■ Letter 82: Arc Ecology (1/12/10)

RE: Public Comment on Candlestick Point-Hunters Point Shipyard Phase II Development Plan Project (formerly the "Bayview Waterfront Project") Draft EIR [DEIR]

**Preliminary comments on selected impacts and mitigation measures listed in  
Table ES-2. Michael F. McGowan, Ph.D. Staff Scientist, Arc Ecology.  
12/8/2009**

**COMMENTS ON THE CANDLESTICK POINT-HUNTERS POINT  
SHIPYARD PHASE II DEVELOPMENT PLAN PROJECT DRAFT EIR  
DATED NOVEMBER 12, 2009**

### **Response to Comment 82-26**

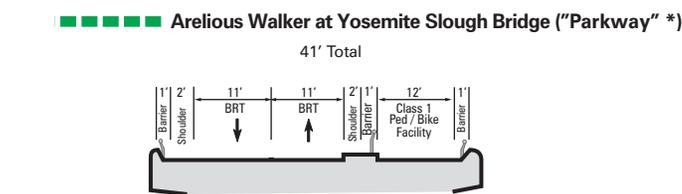
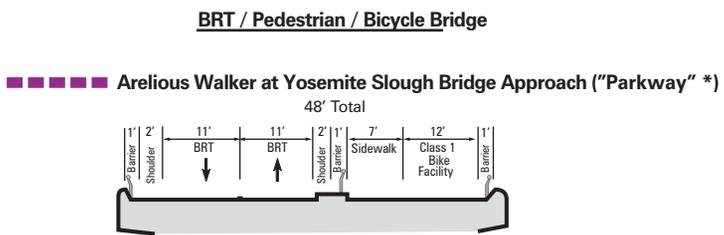
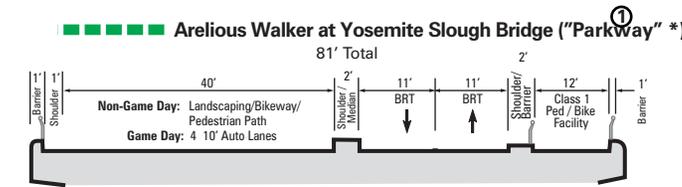
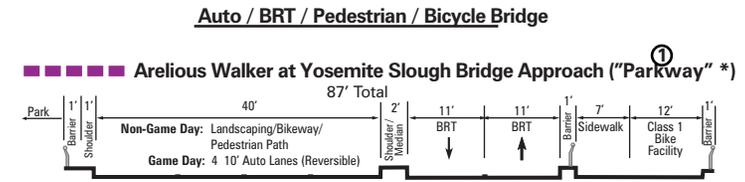
*Comment 26:* The Draft EIR assumes that a greater number of lanes exiting the stadium parking lot is beneficial, but provides no analysis demonstrating that the number of vehicles delivered by Ingalls Street and the bridge (three outbound lanes each) will not exceed the capacity of the Harney Way and 3rd Street ramps and U.S. 101. It is possible that metering the flow of vehicles exiting the parking lot, by not providing a bridge, would result in more efficient handling of vehicles and reduce the level of queuing and congestion on local streets.

The intent of the statement was to note that game-day traffic impacts would be exacerbated under Alternative 2 without the bridge compared to the Project. In response to the comment, the text in Section VI.D (Environmentally Superior Alternative), second paragraph, second and third sentences, page VI-160, has been revised as follows:

... Alternative 2 (CP-HPS Phase II Development Project, HPS Phase II Stadium, State Parks Agreement, and without the Yosemite Slough Bridge) would avoid Project impacts related to biological resources, water quality, and hazardous materials because the Yosemite Slough ~~bridge~~ would not be constructed. However, because the Yosemite Slough bridge would not be constructed, Alternative 2 would result in increased traffic-related impacts, ~~particularly~~ on game days. ...

**Candlestick Point — Hunters Point Shipyard Phase II EIR  
 CROSS-SECTION OF THE YOSEMITE SLOUGH BRIDGE  
 WITH STADIUM AND WITHOUT STADIUM**

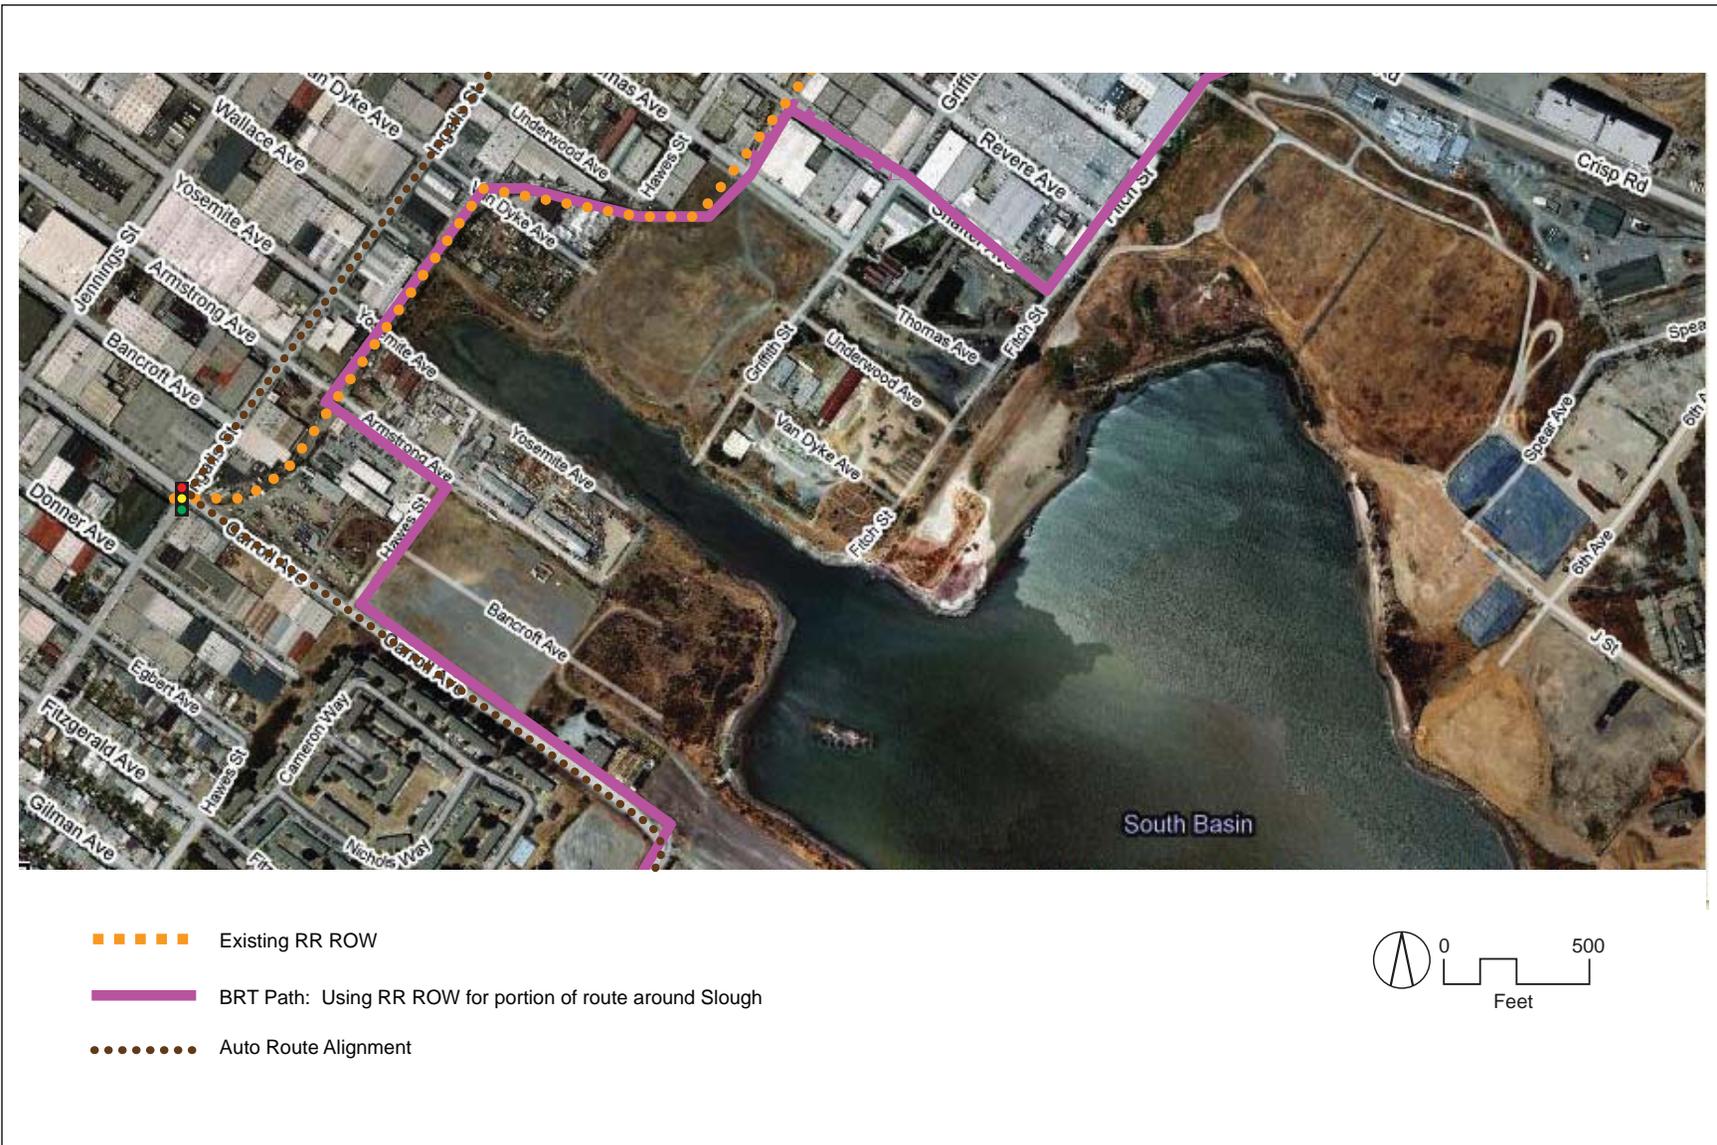
No figure is presented to illustrate the design of the bridge's transportation elements. Page 38 of Section 2, Project Description, provides a written description that is later repeated in other sections. The 81-foot bridge would provide two 11-foot bus rapid transit (BRT) lanes, a 12-foot Class 1 bicycle and pedestrian path, and four game-day lanes. After the BRT lanes and bicycle path have been accounted for, 47 feet remain for the game-day lanes and the separation between lanes.
